Subject: Response to E-mail dated June 18, 2002 regarding FCC ID: LP59003T

The purpose of this letter is to respond to your questions regarding the recent certification of an intentional radiator manufactured by Kidder Industrial Limited.

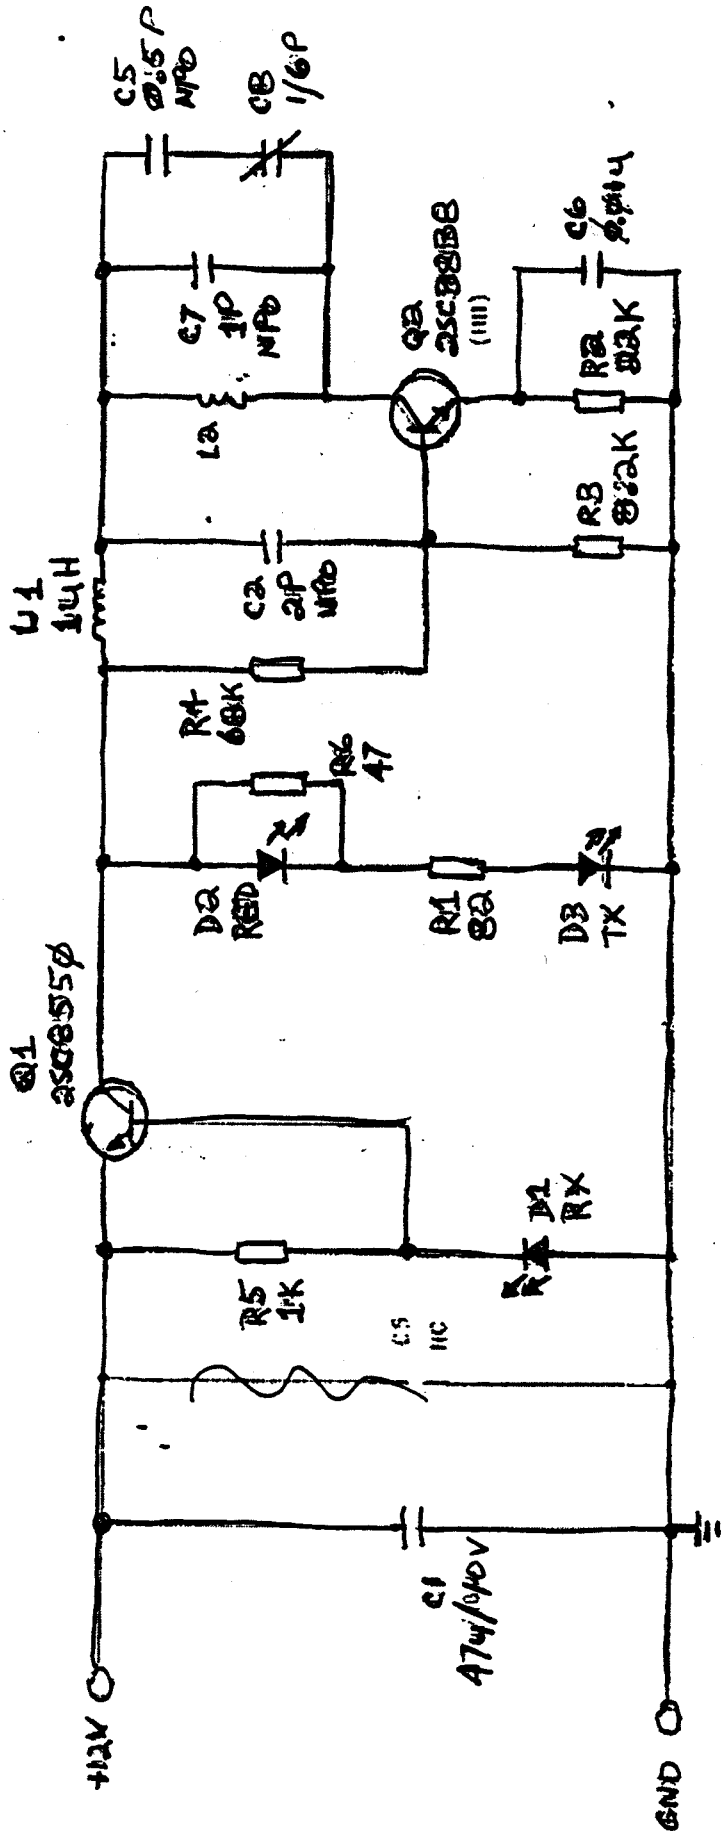
- 1) Most of the component values on the schematic could not be determined.

I have included a replacement schematic which clearly shows all component values. It is labeled as Exhibit 1.
